Client
**The Littlehampton Yacht
Club**

Site
Hampton Quay

Part E: Stakeholder Comment Response

Comment Response Sheet

Part D: Drainage Strategy Overview

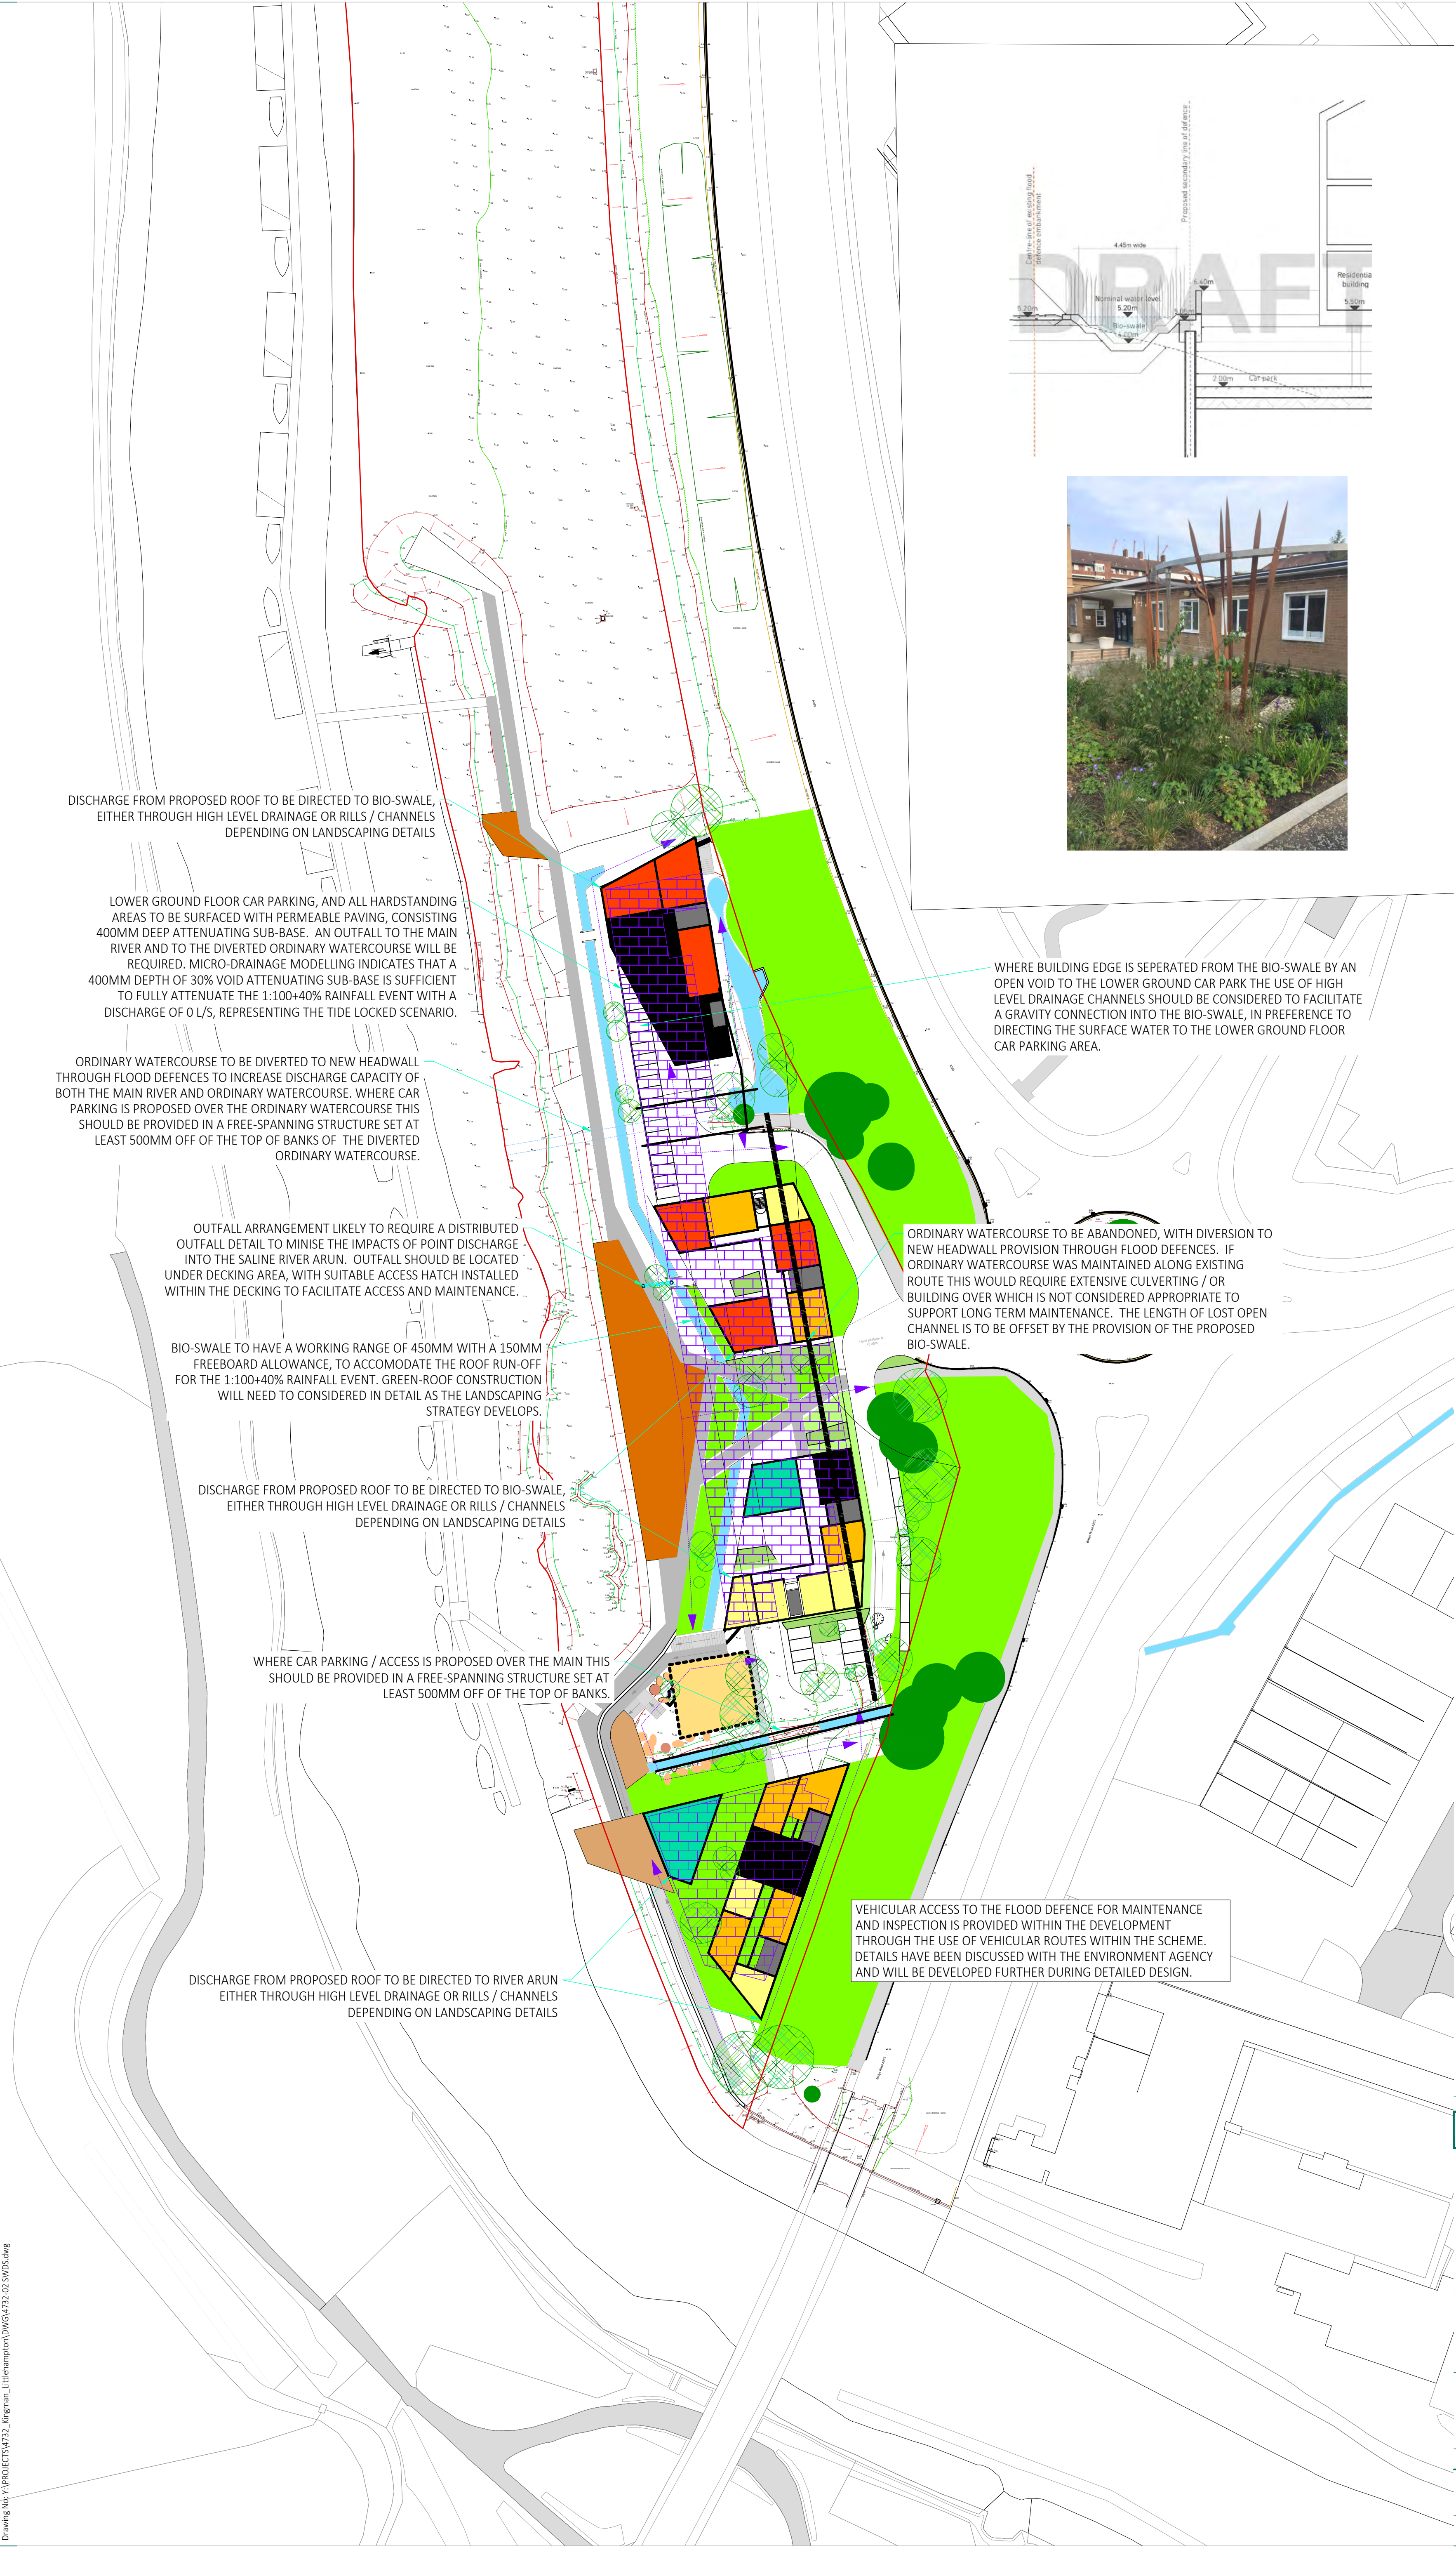
Reference	Comment	Response	Accepted?
5.	It would appear that the development proposes to culvert a significant length of Ordinary watercourse. Further information on culverting a watercourse can be found at https://www.arun.gov.uk/surfacewater/ . In terms of the 'ordinary watercourse' passing through the site, no buildings or structures will be permitted over or within 3 metres of it. Culverting will only be permitted where necessary to facilitate vehicular access across it. The layout at present conflicts with our requirements and would be objected to. Any alterations to the watercourse, including discharging too, culverting, etc will also require Land Drainage Consent.	The guidance provided from the link states: <i><u>"Culverting (piping) a watercourse is not advised unless there is no alternative. The resulting reduction in storage volume, flow capacity and habitat potential would be unacceptable. Culverted watercourses are also more difficult to maintain due to the limited accessibility."</u></i> The published policy contradicts the advice provided in the response, which implies that culverting can only be for vehicular access. The upstream sections of the watercourse are restricted by culverts, and therefore providing a culvert of greater flow capacity would offset the perceived risk, as outlined in the FRA. The proposed swale could be used to provide compensatory habitat, for the loss of open watercourse. Section 23, 3¹, of the Land Drainage Act states that with regards to culverting or other structures on watercourses "consent is not to be unreasonably withheld". An alternative could be to divert the Ordinary Watercourse to a new outfall on the Tidal River Arun, to minimise the amount of culverting. It should be noted that the upstream sections of watercourse are heavily urbanised, with little evidence of open watercourses visible from aerial photography.

7.	Point 5.45 – The FRA states that “Drainage of the under-croft parking areas should be directed to a foul network, as these are unlikely to receive significant rainfall ... These pumps should be isolatable should the under-croft parking area become flooded due to discharges from the culverts entering the site.” It is my understanding that the proposed floor level is below the 1:1 year storm threshold and therefore should the defences become compromised the carpark would be	The under-croft car park area would not be subject to significant amounts of rainfall. Normal design of basement and multi-storey car park drainage (for covered areas) is to direct this to the foul drainage network. Should Arun insist on a deviation from this normal design practice, then a full retention petrol interceptor could be provided upstream of the outfall to the Ordinary Watercourse.
